**DELRAY
BEACH CLUB
RAISED TENNIS
& COVERED
PARKING**

**2001 S. OCEAN BLVD.
DELRAY BEACH, FL.**

THIS DRAWING IS NOT FOR CONSTRUCTION,
IT HAS BEEN ISSUED FOR GOVERNMENTAL
REVIEW AND/OR PRELIMINARY PRICING
ONLY

**PROPOSED
ELEVATIONS**

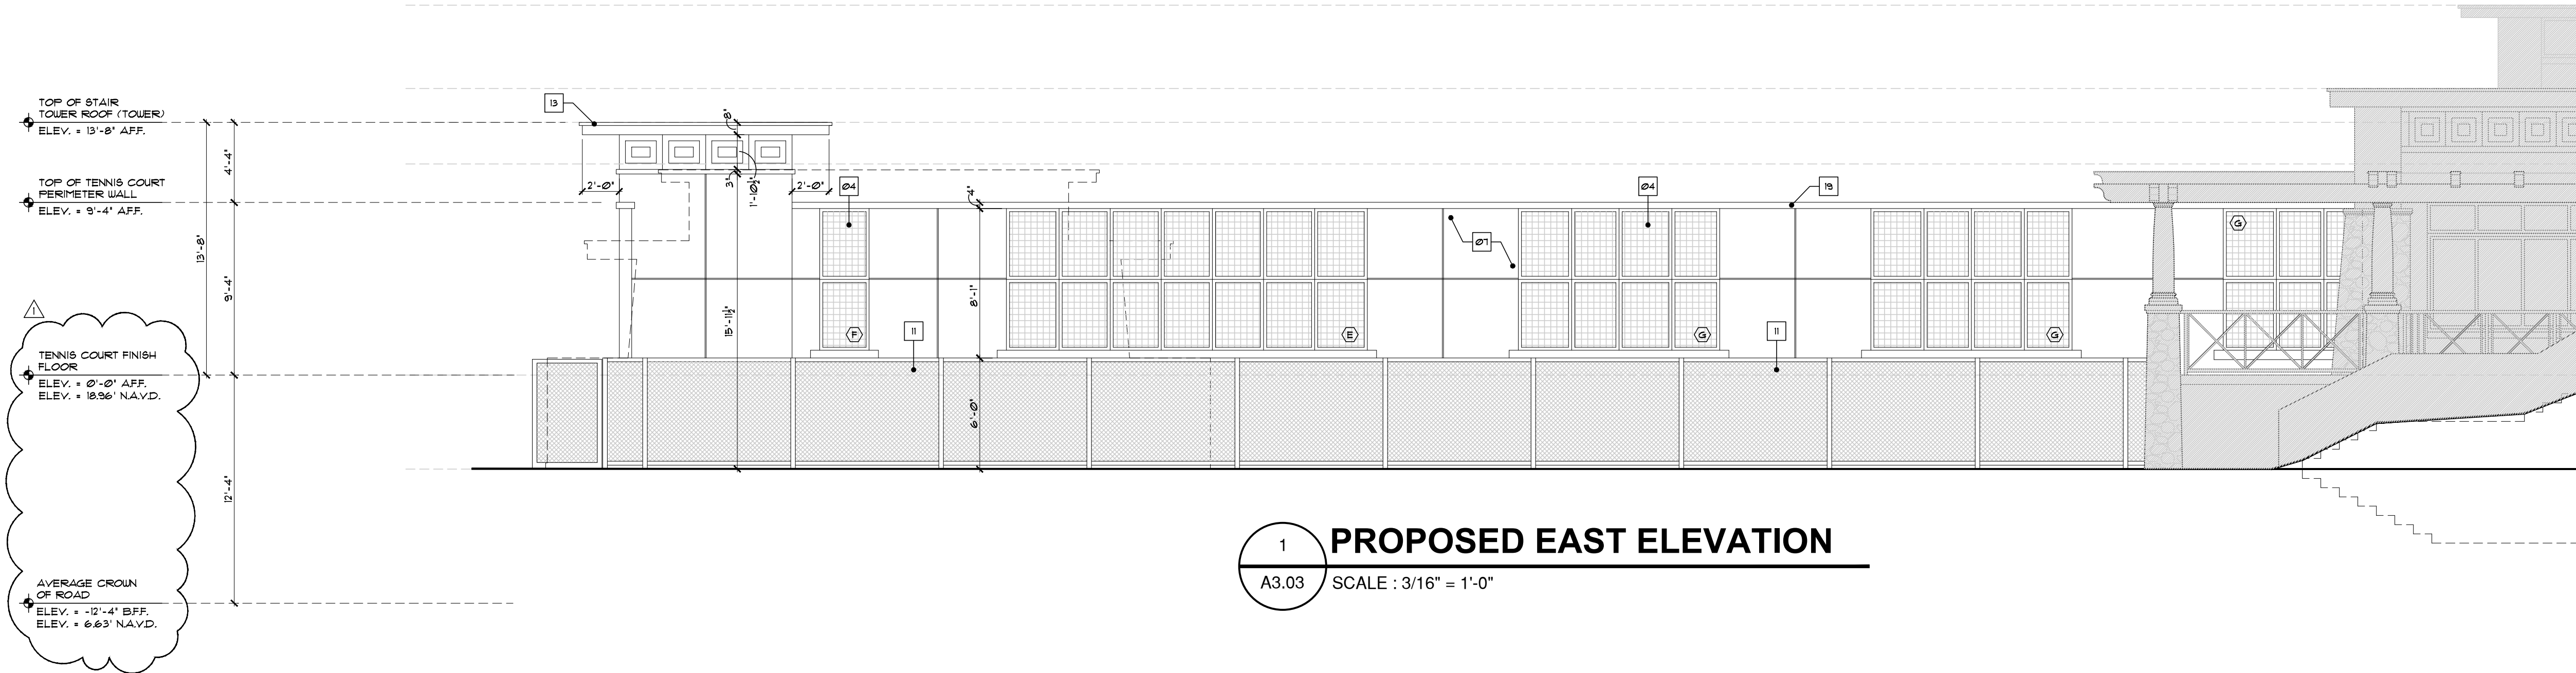
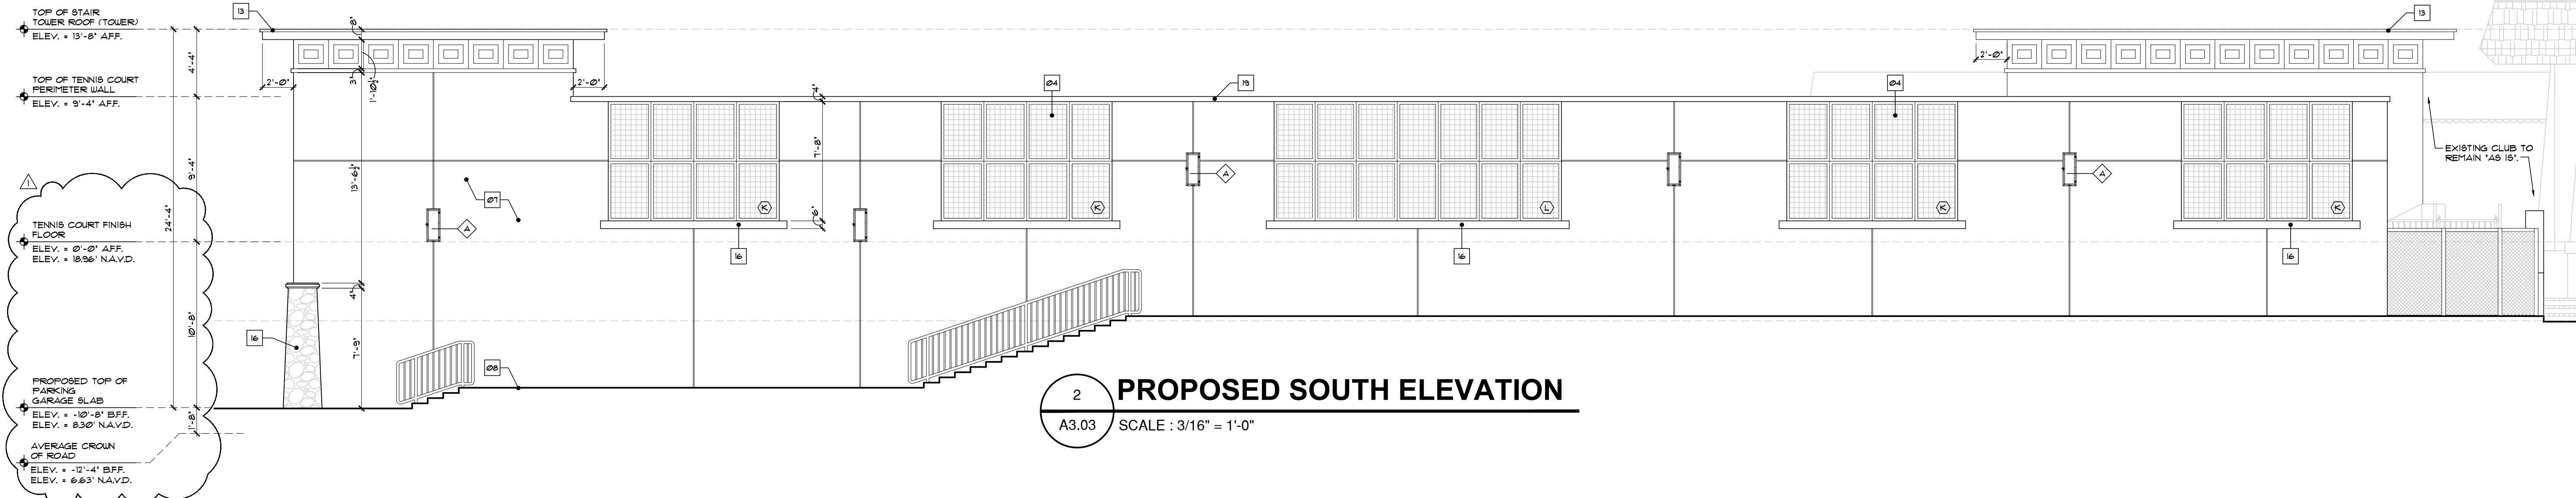
REVISIONS
REVISED 9.3.21 AS PER PLANNING AND ZONING COMMENTS:
1. MURAL CONCH HAS BEEN NOTED TO BE UNDER A SEPARATE PERMIT.
2. TURTLE LIGHTS HAVE BEEN SPECIFIED FOR ALL EXTERIOR LIGHTING FIXTURES.
3. REVISED ELEVATION HEIGHTS TO MATCH CIVIL DRAWINGS.
